**APPENDIX F**  
**DRAFT EIR COMMENTS AND RESPONSES**

## Appendix F - Draft EIR Comments and Responses

The 45-day public review period for the Draft Environmental Impact Report (EIR) began on March 31, 2008 and ended on May 15, 2008. During the public review period, six written comment letters were received from public agencies, private organizations and one individual. Table F-1 lists the persons, organizations, and agencies that submitted comments on the Draft EIR for the River Supply Conduit Improvement – Upper Reach project.

Re: Draft EIR – RSC Improvement Upper Reach – Unit 7

FIGURE 1

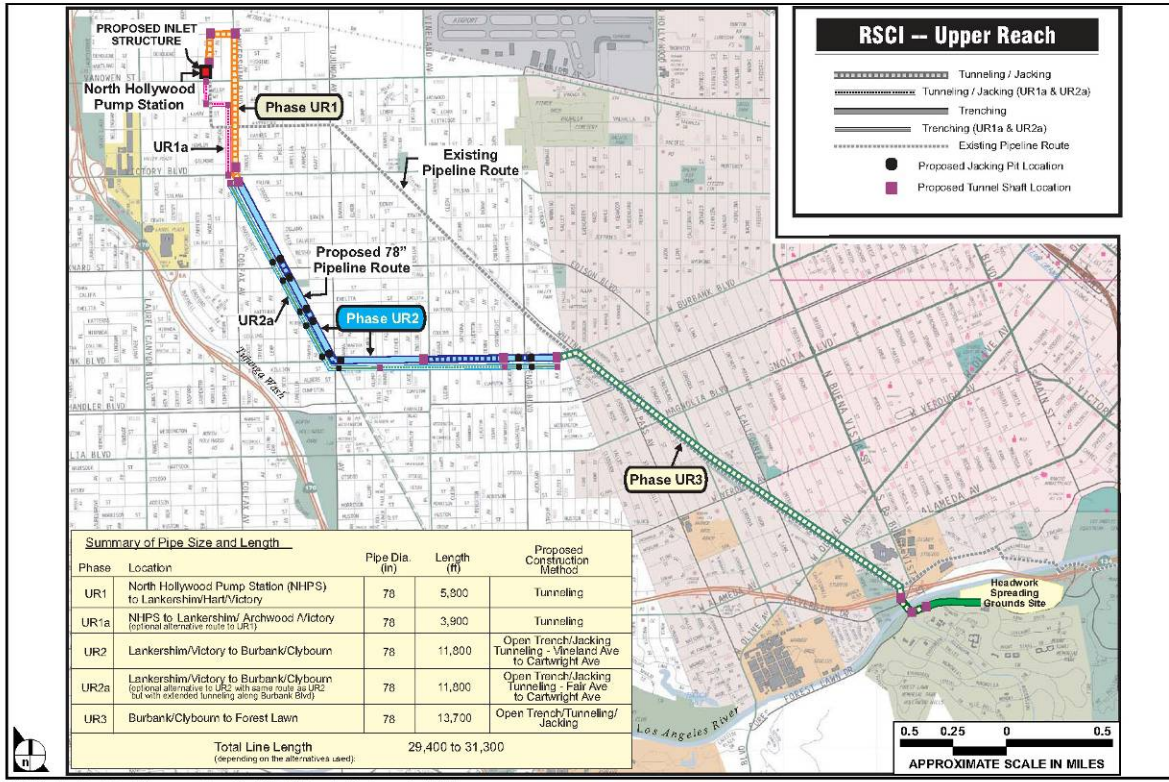
- Section, 3.1 Project Description,
- Section, 3.2, Noise and Vibration,
- Section 3.3, Transportation,
- Section 3.4, Air Quality,
- Section 3.5, Recreation, and
- Section 3.6, Geology and Hydrology.
